# E.6 PLANNING SCHEME AMENDMENT C81 - LAND SUBJECT TO INUNDATION OVERLAY - ADOPTION

Appendix 1 – Planning Scheme Amendment C81 Panel Report

South Gippsland Planning Scheme Amendment C81 Land Subject to Inundation Overlay

Panel Report pursuant to Section 25 of the Act

# **Appendix D** Changes to LSIO mapping

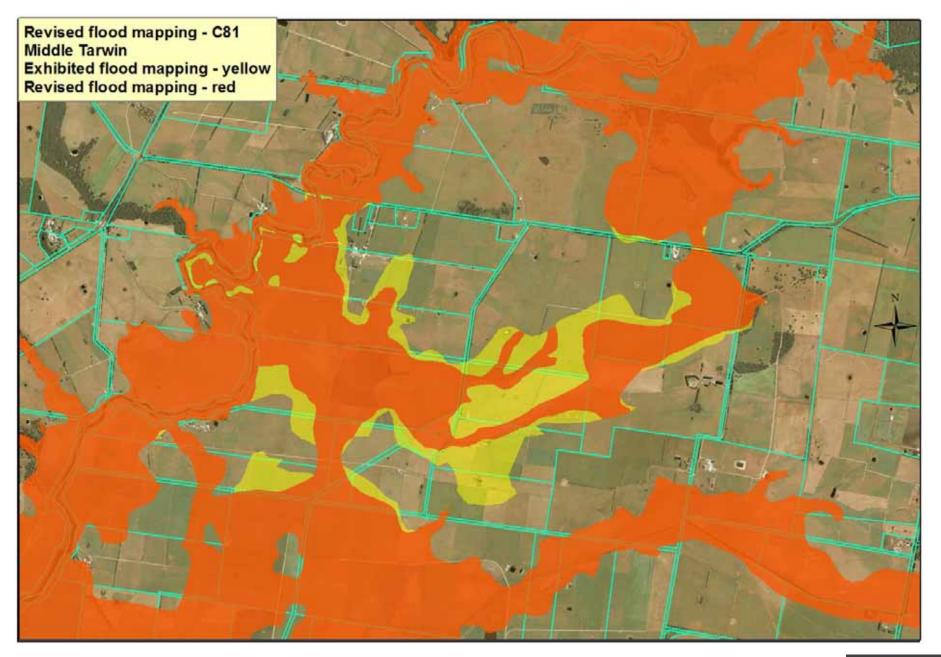
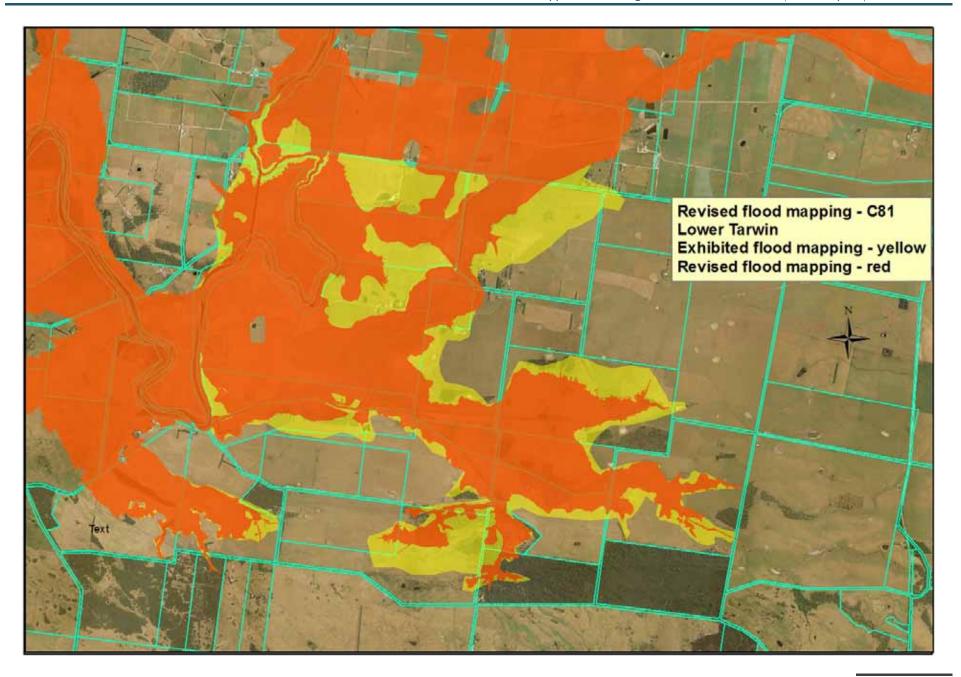
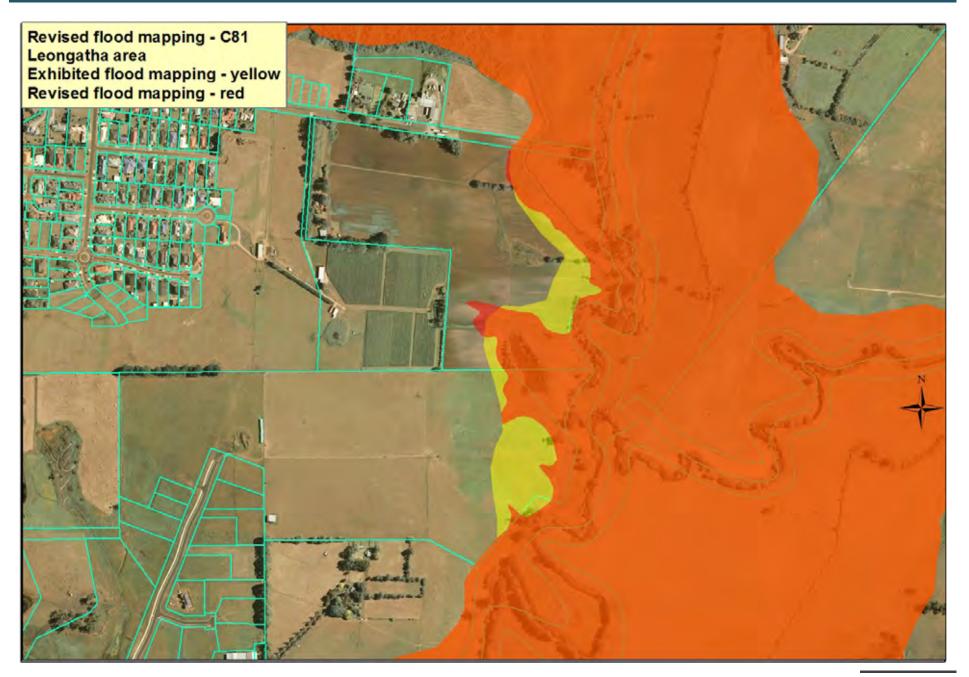
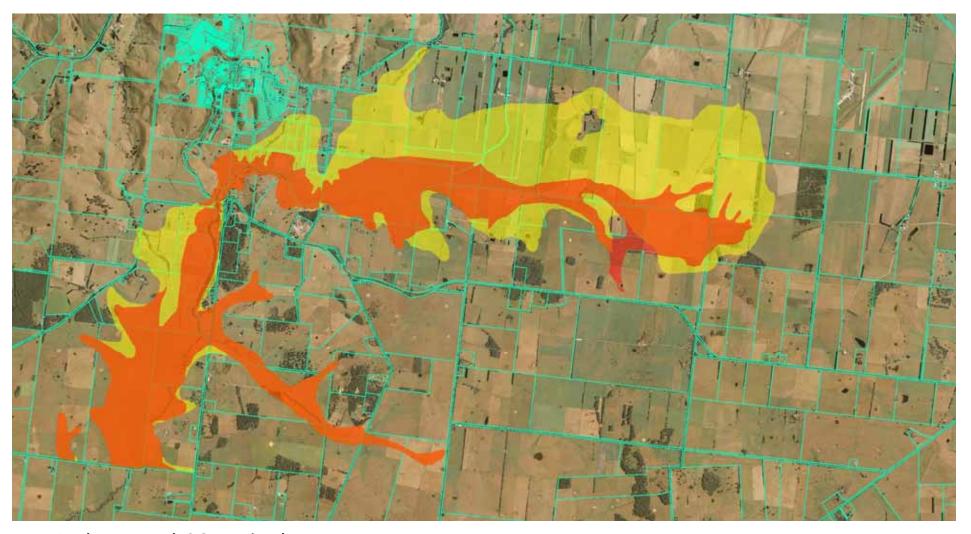
The WGCMA advised that they were contacted by a number of landowners in the Lower and Middle Tarwin River catchments to discuss the extent of the proposed LSIO in those areas. Following on-site visits with landowners and further investigation using LiDAR, WGCMA have proposed revised LSIO mapping in those areas. It is understood that the revised mapping is agreed by the landowners.

The WGCMA advised that they were contacted by Mr Murrihy to discuss the extent of the proposed LSIO on his property east of Leongatha. Following on-site visits and further investigation using LiDAR and aerial photography, WGCMA have proposed revised LSIO mapping in those areas. It is understood that the revised mapping is agreed by Mr Murrihy.

3. Amend the revised extent of the Land Subject to Inundation Overlay in the Lower Tarwin, Middle Tarwin, Leongatha and Upper Powlett areas consistent with the maps shown in Appendix D of this report.
